**Residential Development Adamstown**

Area 5 - Tubber Lane

**ARCHITECTURAL DESIGN STATEMENT**

Clarification of Further Information Response

Figure 2 5 x TAU location and Unit 400 Location

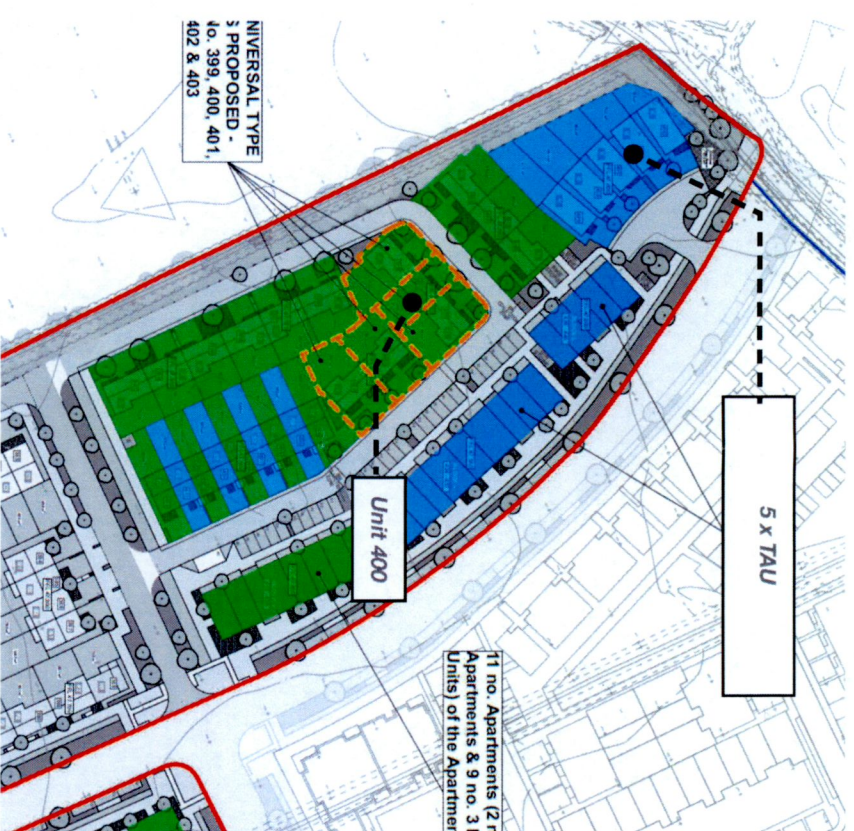
At Further Information stage, the applicant was requested to make contact with the Housing Department regarding Part V. The Housing Department has raised concerns regarding the submission with regards TAU obligations. It is noted that 6 units are proposed, however, the preference is for detached units. The applicant is requested to engage further with the SDCC Housing Department and address this.

The applicant is requested to provide an updated schedule of accommodation, reflecting any changes.

South Dublin County Council Housing Section were contacted by the applicants and it was agreed to provide 5 detached units in a revised arrangement [see Figure 1 over]. The remaining unit [out of initially proposed 6 units] is proposed as an additional standard Part V unit. This unit is identified as unit No 400 as highlighted on the map at Figure 2 opposite.

Figure 3 Location and elevation of G1 and G2 Terrace

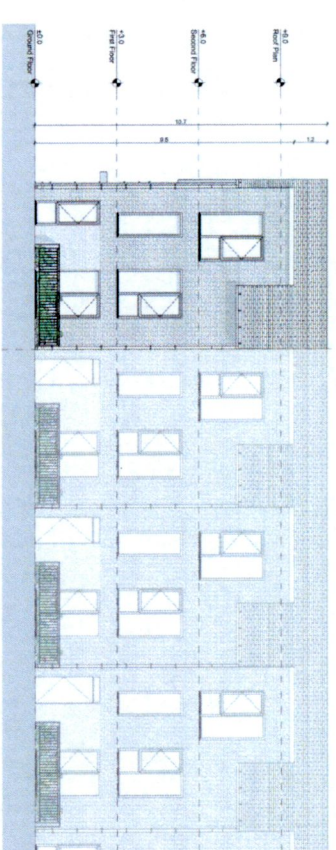
**CFI 2A** There is concern that the dwellings to the north east corner, fronting the park, are highlighted as perimeter and the applicant is only proposing 2 storey. In order to achieve compliance with the Planning Scheme, building heights should be increased to 3 storey.

The height of buildings at the location highlighted have been increased to 3 storey townhouse types (G1 and G2 Types). See partial elevation of this terrace highlighted and location confirmed at Figure 3 opposite.

Figure 5 Revised Gable Elevations C1, D1 and E3

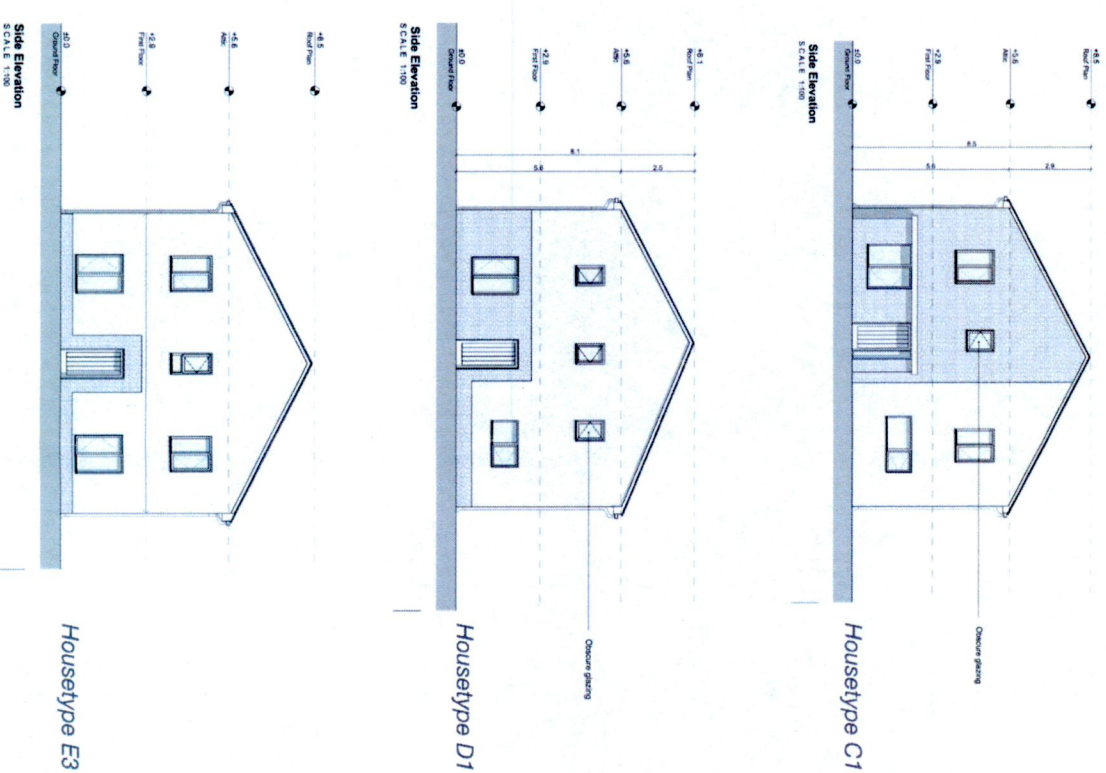
- C1, D1, E3 – first floor windows should be provided

First floor windows have been provided to C1, D1 and E3 as illustrated at Figure 5 below.

Figure 6 Revised Gable Elevations J1 and I1

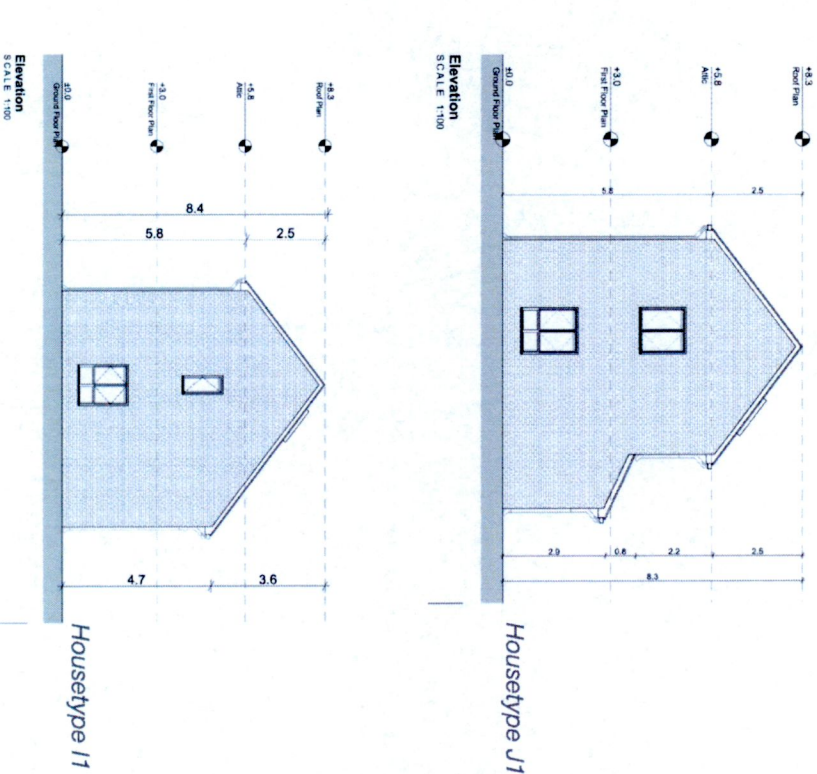
- J1, I1 – bay window should be removed and it should be dual aspect at ground floor and first floor.

Bay window has been removed. Ground and first floor windows have been introduced to address dual aspect - as illustrated at Figure 6 below.
